Access Compliance Report

Public Rights-of-Way

Intersection ID: 14147	Main Street: CHERRY_ST	Cross Street: LUTHER_ST	Location: SE
ADA ID: 7A8FABF949C6	Ramp Type: PerpDiag	Initial Pass/Fail: Fail	Overall Compliance: No
		Severity Score: 10

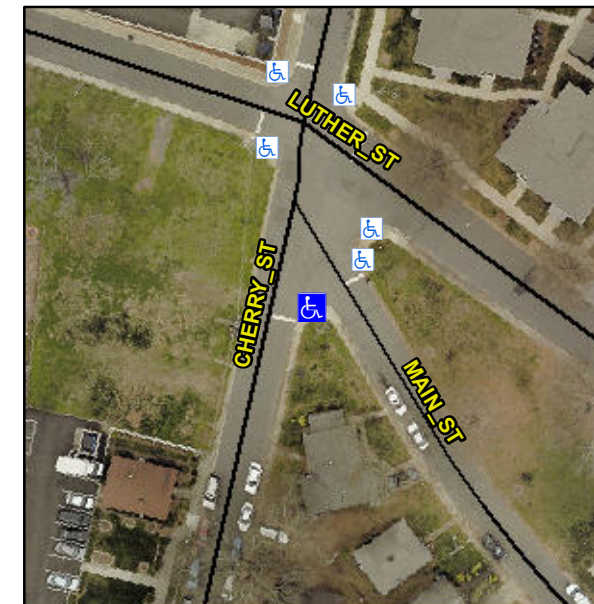
R304.5.1, R304.5.3

Compliance	Description	Data	Compliance	Description	Data
N/A	Ramp Length (in)	72.5	Yes	Ramp Slope (%)	5.3
No	Ramp Width (in)	47.0	No	Ramp XSlope (%)	3.6
N/A	Flare Type LT	N/A	N/A	Flare Type RT	N/A
N/A	Flare Slope LT (%)	N/A	N/A	Flare Slope RT (%)	N/A
N/A	Flare Traversable LT?	N/A	N/A	Flare Traversable RT?	N/A
N/A	Landing Length (in)	N/A	N/A	DWS Provided?	N/A
N/A	Landing Width (in)	N/A	N/A	DWS Contrast?	N/A
N/A	Landing Slope (%)	N/A	N/A	DWS Length (in)	N/A
N/A	Landing X Slope (%)	N/A	N/A	DWS Full Width?	N/A
N/A	Landing Curb? (Y/N)	N/A	N/A	DWS Offset (in)	N/A
N/A	Shared Landing?	N/A			
N/A	Gutter Ponding?	N/A	N/A	Gutter Slope (%)	N/A
N/A	Gutter Lip Ht (in)	N/A	N/A	Gutter X Slope (%)	N/A
N/A	Painted X Walk1?	No	N/A	Painted X Walk2?	No
	X Walk 1 Direction	To NE		X Walk 2 Direction	To NW
N/A	X Walk 1 Width (in)	N/A	N/A	X Walk 2 Width (in)	N/A
	X Walk 1 Slope (%)	3.5		X Walk 2 Slope (%)	0.3
	X Walk 1 X Slope (%)	3.2		X Walk 2 X Slope (%)	0.1

Remove & Replace Curb Ramp With Two New Directional Ramps or Equivalent.
